**FINAL ENVIRONMENTAL IMPACT REPORT
SAN DIEGO CLEAN FUELS FACILITY LLC PROJECT**

September 2025

**City of National City
1243 National City Boulevard
National City, California 91950**

3-13

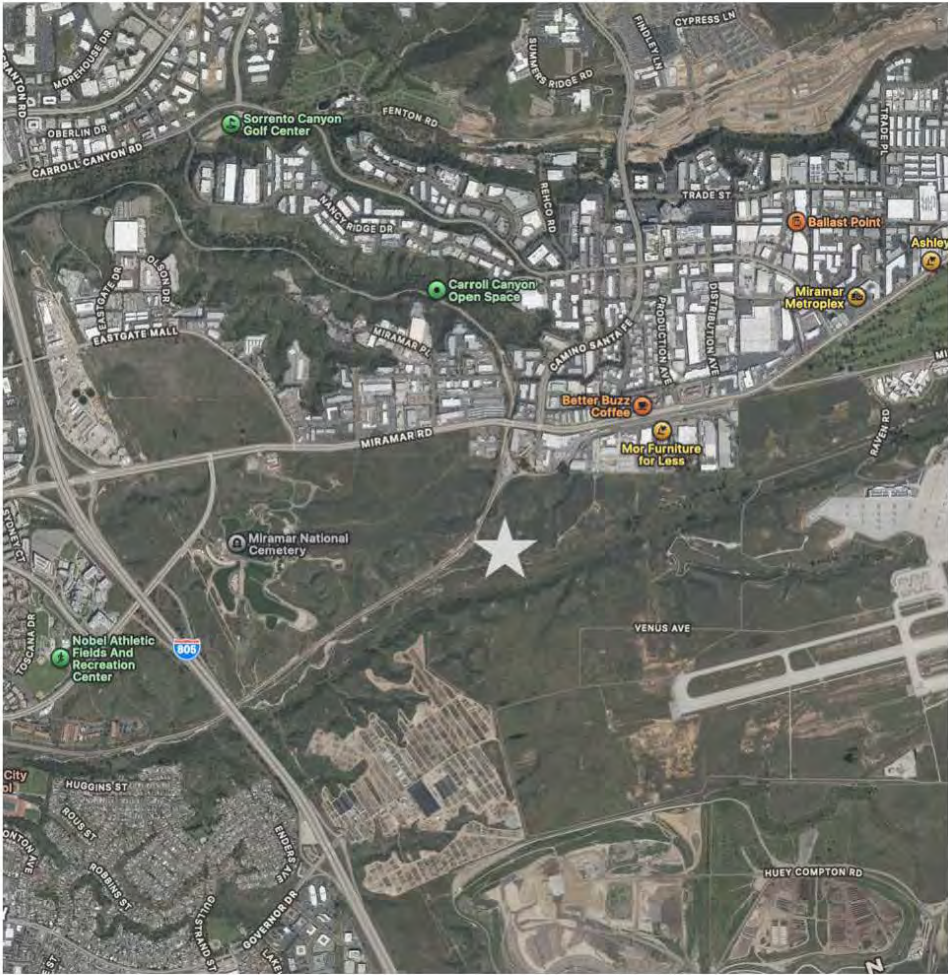
This comment states the Draft EIR has not considered a range of possible offsite alternatives. The commenter suggests moving the project away from residential areas such as in areas along the railroad in San Diego County. The commenter suggests an alternative site to analyze.

This comment provides a map of the alternative location proposed by the commenter in Comment 3-11. The proposed alternative location is marked by a grey star. No response to this comment is necessary.
